Economic Commission for Europe**Inland Transport Committee****World Forum for Harmonization of Vehicle Regulations****Working Party on Noise****Sixty-fourth session**

Collective amendments**Proposal for a Supplement to Regulation No. 63****Submitted by the expert from the European Commission***

"Uniform provisions concerning the approval of L₁ category vehicles ~~two-wheeled mopeds~~ with regard to noise sound emission

Figure 1
Measuring positions for vehicles in motion

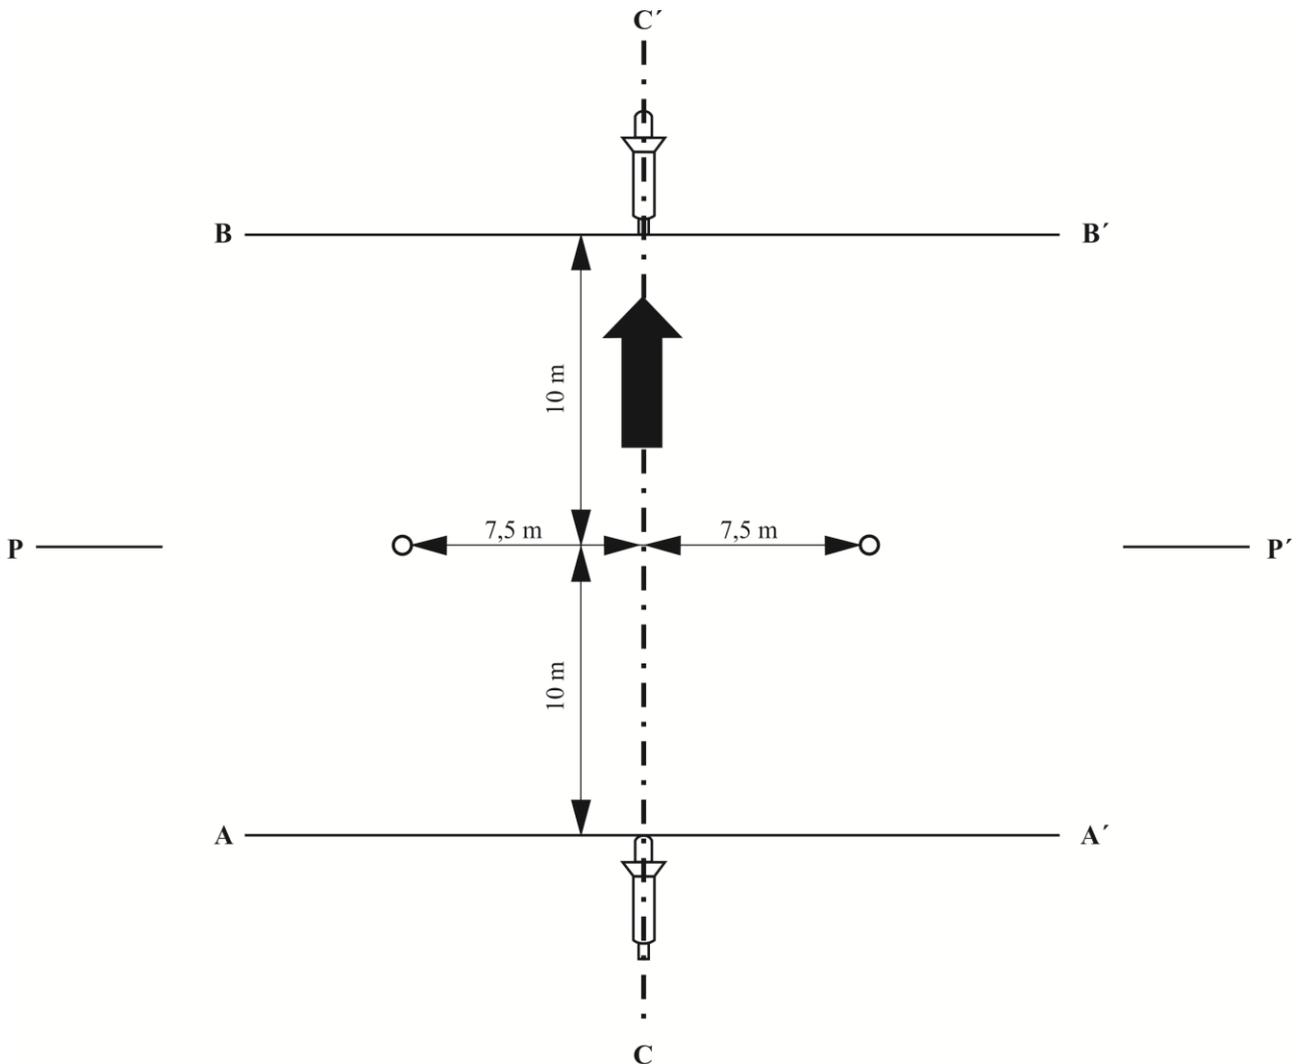
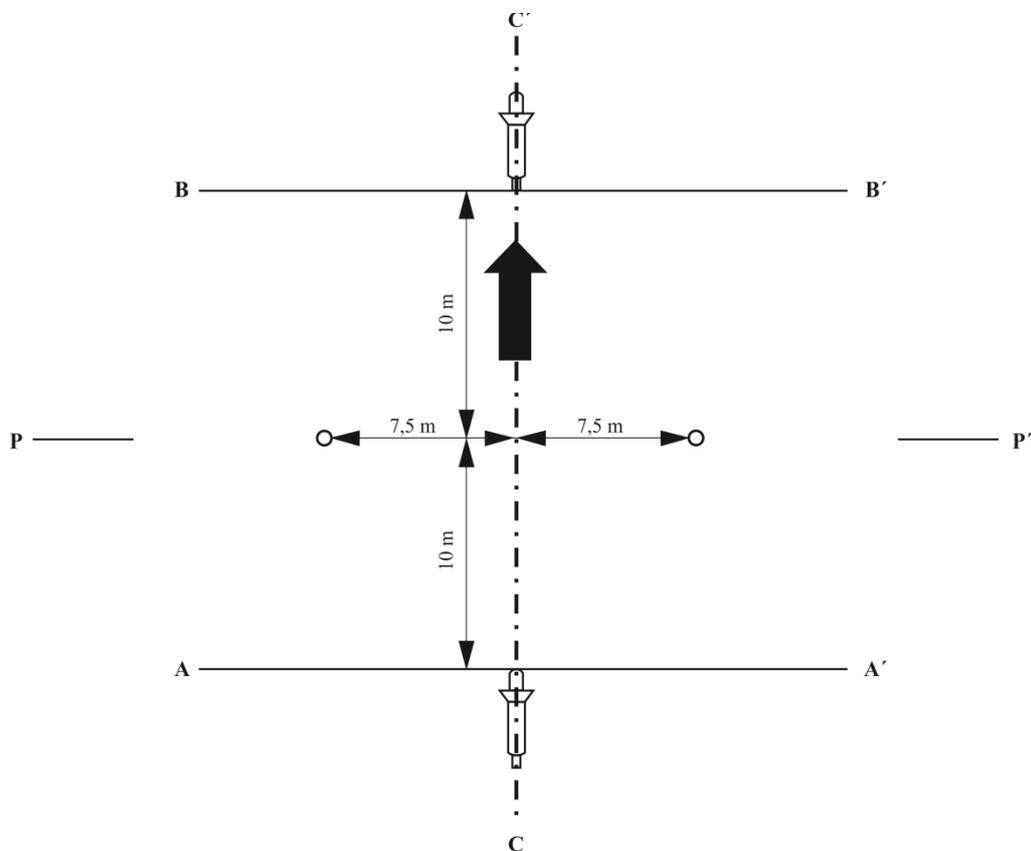
28. Header 3.1.1. "General conditions of test" was replaced by "Test arrangement and microphone positions". Figure 1 was moved from the current position to this paragraph.

Figure 2
Measuring positions for the measurement of sound of the stationary vehicles

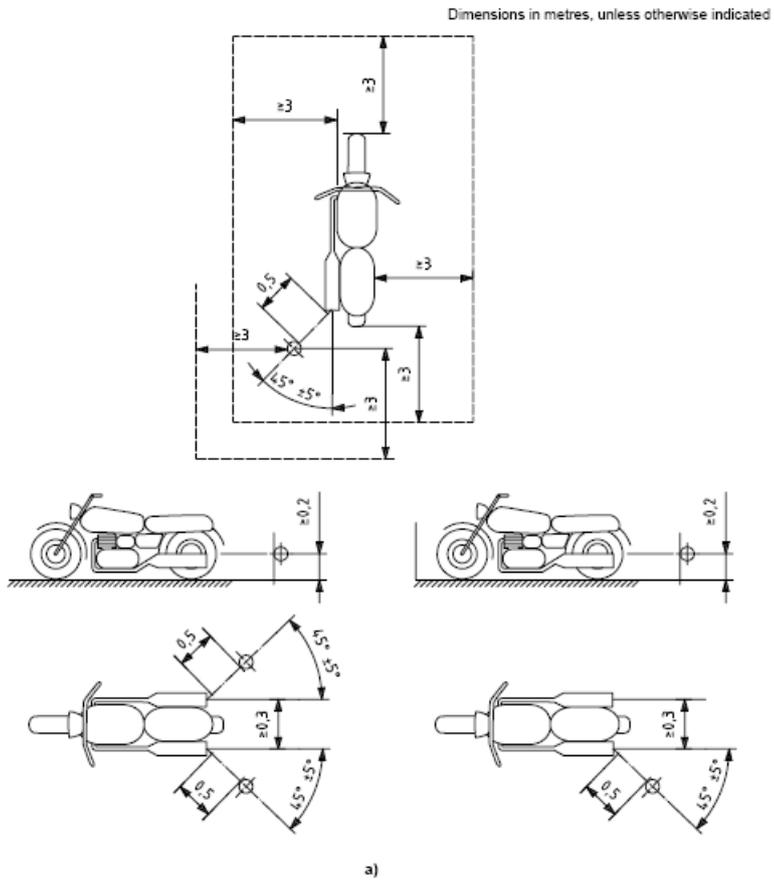
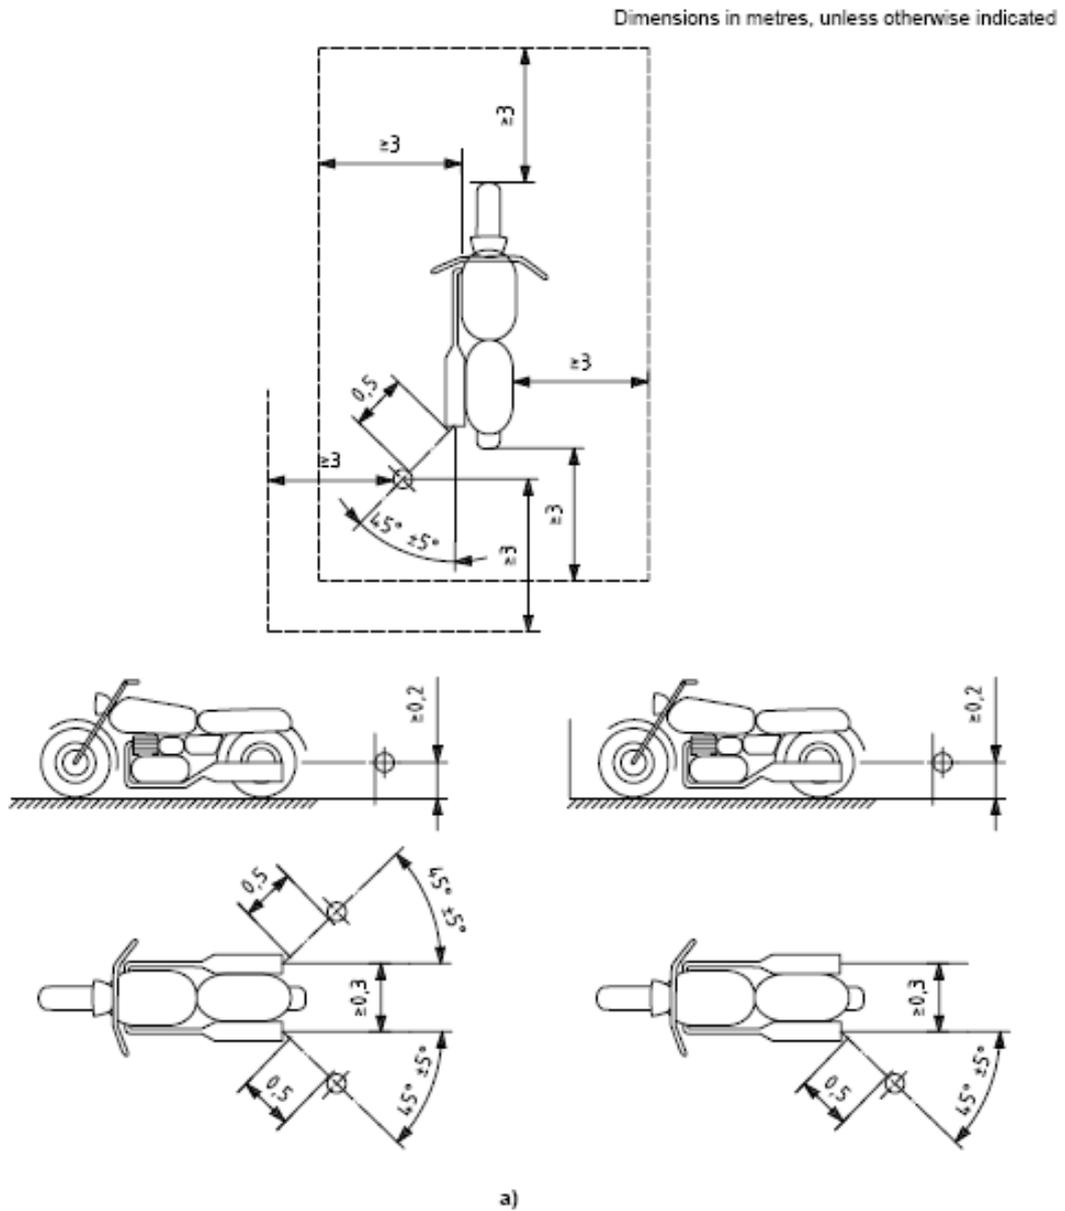
32. Figures 2 and 4 were moved from the current positions to this paragraph, because they belong to it. Figure 4 was renamed to figure 3 in order to ensure the right order.

Figure 3
Reference point

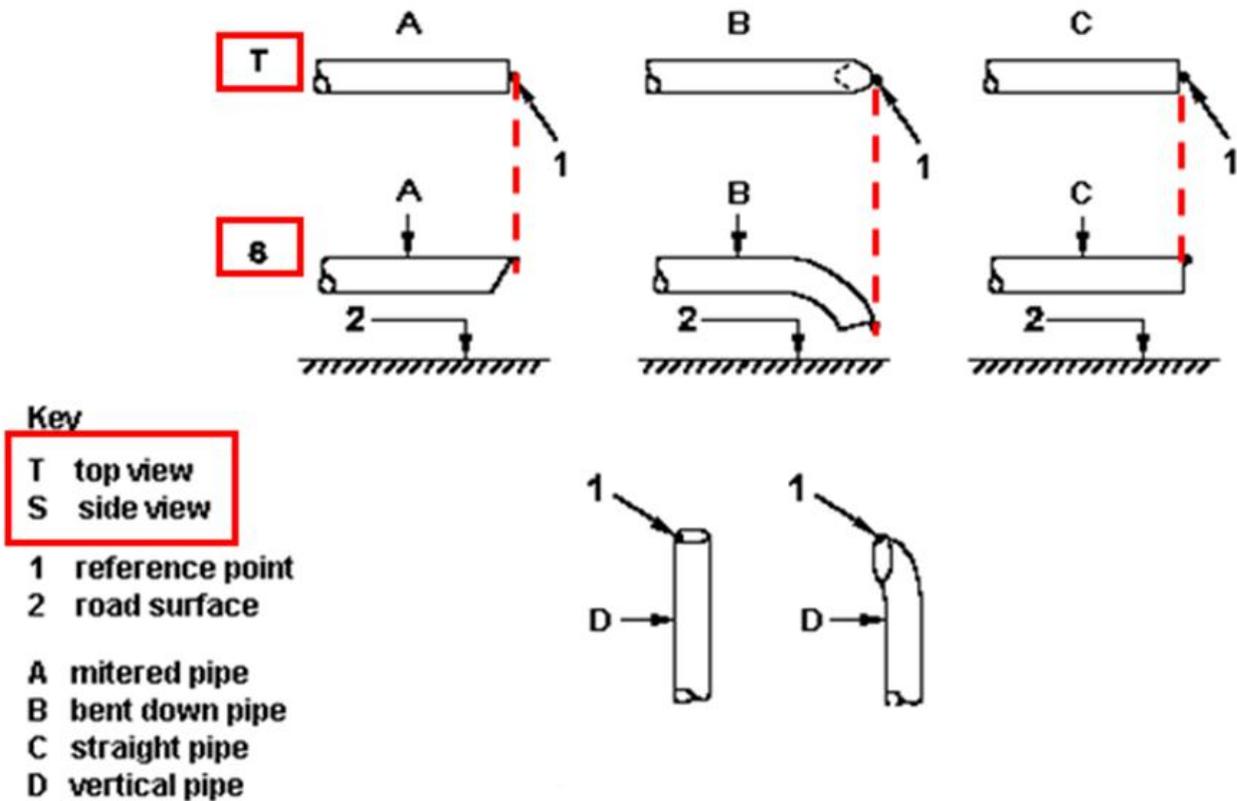
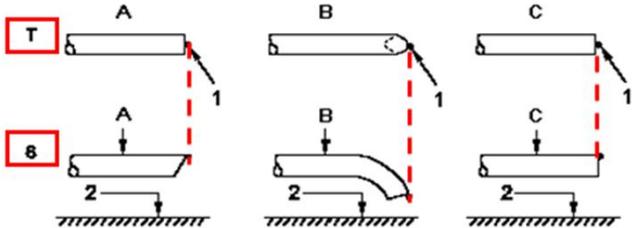
The microphone shall be located at a distance of 0.5 ± 0.01 m from the reference point of the exhaust pipe defined in ~~figure 4~~ figure 3 and at an angle of $45^\circ \pm 5^\circ$ to the vertical plane containing the flow axis of the pipe termination. The microphone shall be at the height of the reference point, but not less than 0.2 m from the ground surface. The reference axis of the microphone shall lie in a plane parallel to the ground surface and shall be directed towards the reference point on the exhaust outlet.

Figure 4
Test apparatus for conditioning by pulsation

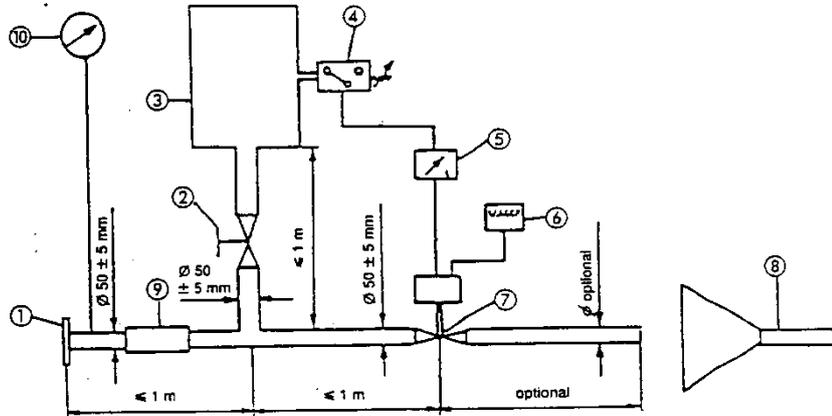
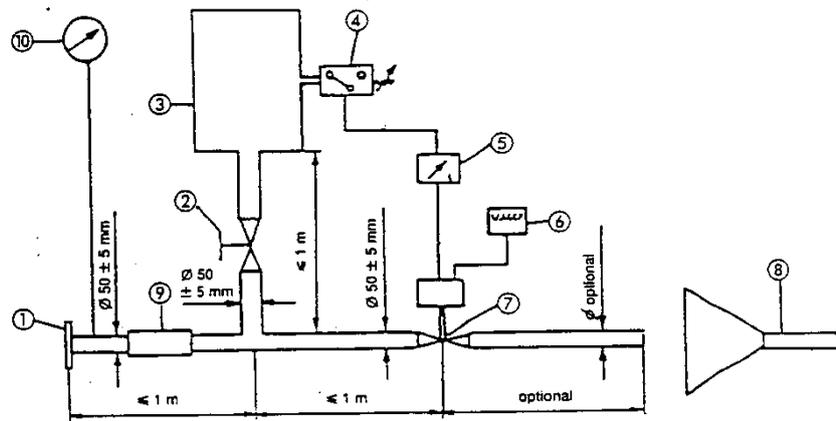
- The test apparatus, a detailed diagram of which is shown in ~~Figure 3~~ **figure 4**, shall be fitted at the outlet of the exhaust system. Any other apparatus providing equivalent results shall be acceptable.

37. Figure 3 was moved from paragraph 5.3. to this paragraph, to which it belongs, and was renamed to figure 4 in order to ensure the right order.
